FCO 512-00197A
Anti-scratch solution for all deep punches

Document number: 719-00360A Rev B.

Component Plate support deep punch assembly. (part number 500-02021A)

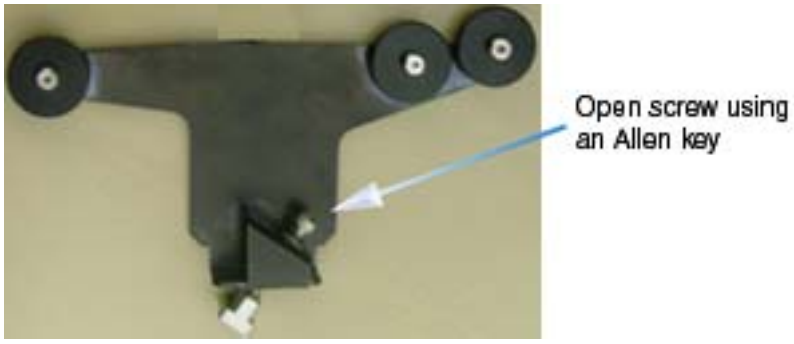
1. In Lotem Controller, open the platesetter's front door.
2. From the punch beam, use a hex key to remove the plate support closest to the deep punch.

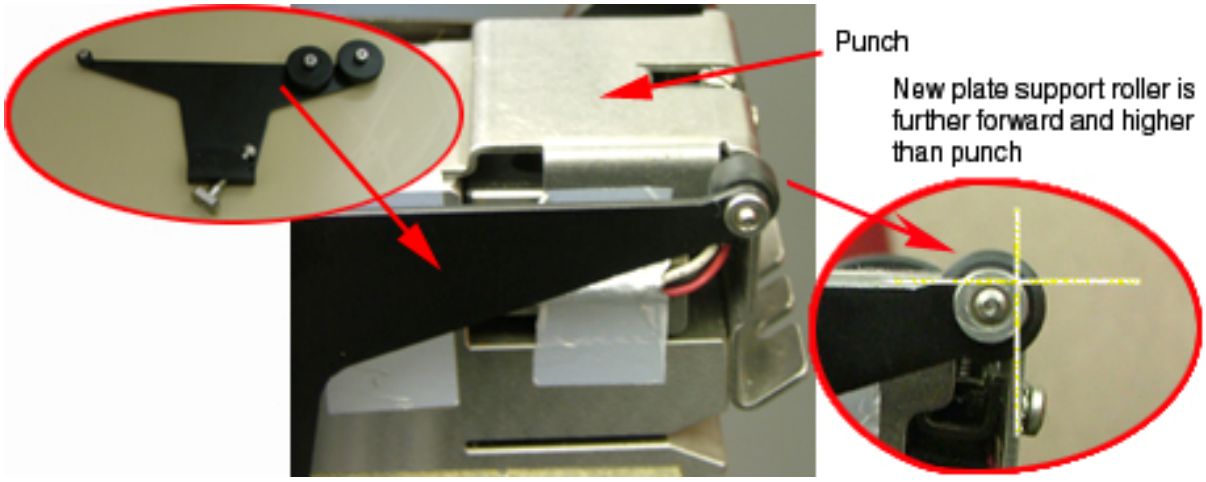
3. Replace the plate support with the improved plate support. Use a hex key to tighten the screw at the base of the plate support. To prevent the plate touching the punch cover, the improved plate support roller is placed further forward and higher than the punch.
